SHAMS STYLING WEARS LTD (Extension)

11 December 2023

2. Observations:

Prepared loan plan on 3rd floor

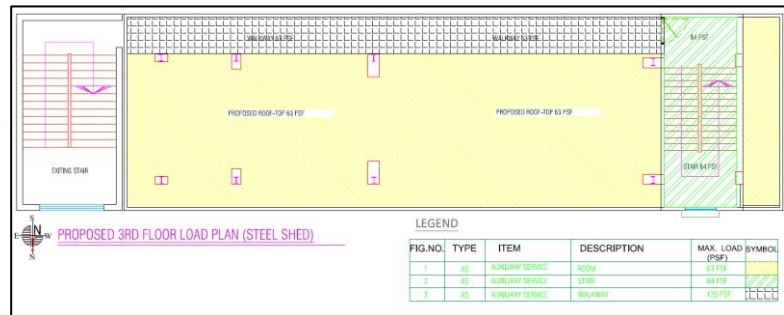
Observation-2: Storage live load does not comply with BNBC requirement. (Utility Building)

Description: The live load on the storage area of the 2nd floor is considered 3 kPa in the prepared load plan. As per BNBC-2006, the live load for light storage areas is required to be considered a minimum 6 kPa. Therefore, the factory engineer is required to revise the load plan as per BNBC requirement and check the design accordingly.
